# MANDATORY

# SERVICE BULLETIN

Service Bulletin No. 646A  
 (Supersedes Service Bulletin No. 646)  
 Engineering Aspects are  
 FAA Approved

SUBJECT: T-Bolt Clamp Inspection

**Figure 1**  
**Non-Conforming T-Bolt Clamp**

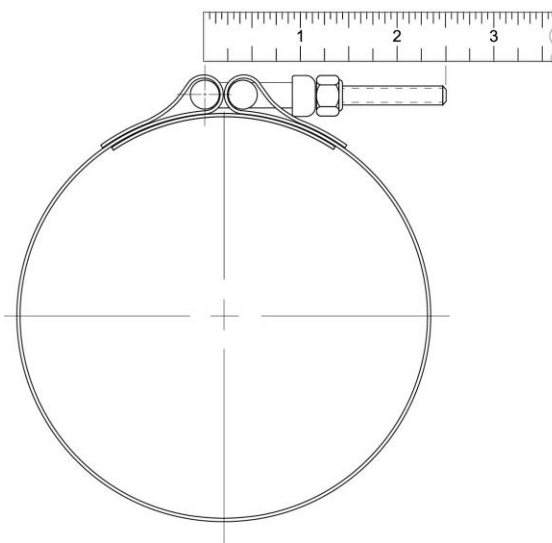
Lycoming has identified non-conforming T-bolt clamps installed on factory-delivered engines or sold as spares from January 2010 to October 2021. The non-conforming T-bolt clamps have no Lycoming part number marking and could have a vendor part number ending in "438-S". Non-conforming T-bolt clamps can also be identified by the bolt length, which measures 2-1/2 inches (Figure 1). Conforming T-bolt clamps can be identified by the Lycoming part number LW-15570 or 07C29900 marking on the clamp and a bolt length of 3 inches (Figure 2).

- B. Remove all T-bolt clamps from your spares inventory that have a bolt that measures 2 ½ inches long (Figure 1).
2. Inspect the T-bolt clamp installed on the engine that secures the hose to the throttle body, on TEO-540-C1A engines, or secures the hose to the fuel injector on the other engine models affected to determine if:

- The bolt measures 2 ½ inches in length (Figure 1).
  - The clamp ends are touching when correctly torqued to 35 in.-lb. (Figure 3).
  - The nut is tightened to the end of the bolt threads before reaching the correct torque of 35 in.-lb.

1. Check your spares inventory for any T-bolt clamps sold as Lycoming P/N LW-15570 and examine for the following:
  - A. Remove all T-bolt clamps from your spares inventory that have no Lycoming part number marking or have a vendor part number ending in “438-S”.

3. If any of the conditions identified in Step 2 of this section exist:
  - A. Remove the clamp.
  - B. Clean the hose, turbo discharge housing, and the throttle body or fuel injector with Stoddard Solution or equivalent.
  - C. Ensure there is no oily residue on the hose, turbo discharge housing, throttle body or fuel injector.
  - D. Inspect the hose for damage and deformities. Replace as necessary.

**Figure 4**

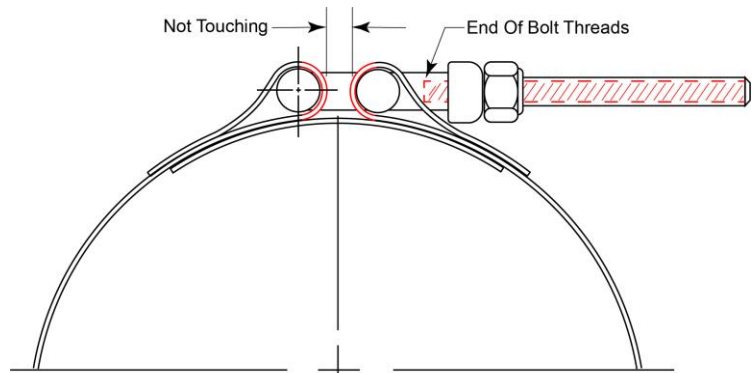
- The clamp must be inspected to ensure that when torqued correctly to 35 in.-lb. the ends of the clamp are not touching (Figure 4) and the intake hose is securely held in place.
- The nut must be correctly torqued to 35 in.-lb. and still have threads remaining on the bottom of the bolt with the clamp ends not touching (Figure 4).

At the owner’s discretion a non-conforming clamp may remain installed provided the following inspection is completed every 50 hours, time-in-service for up to 12 months.

**Figure 5**  
**Intake Hose and Clamps**

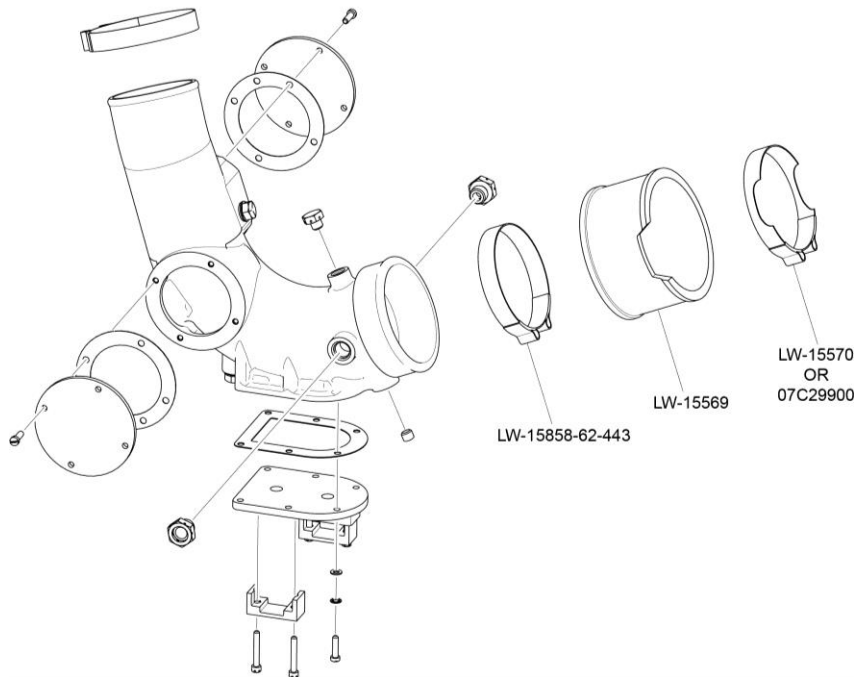
The non-conforming T-bolt clamp would have been installed to secure the large intake hose P/N LW-15569 (Figure 5) to the throttle body, on TEO-540-C1A engines, or to secure the large intake hose to the fuel injector on the other models affected. The non-conforming T-bolt clamps, when correctly torqued to 35 in.-lb., could result in no gap between the clamp ends (Figure 3) or the nut could reach the end of the bolt threads before reaching the correct torque preventing the T-bolt clamp from properly securing the hose.

- E. Order new T-bolt clamps and new hose, as required, from any authorized Lycoming distributor.
  - F. Install the new intake hose (if required) and new T-bolt clamps (Figure 5) in accordance with the applicable maintenance or overhaul manual.
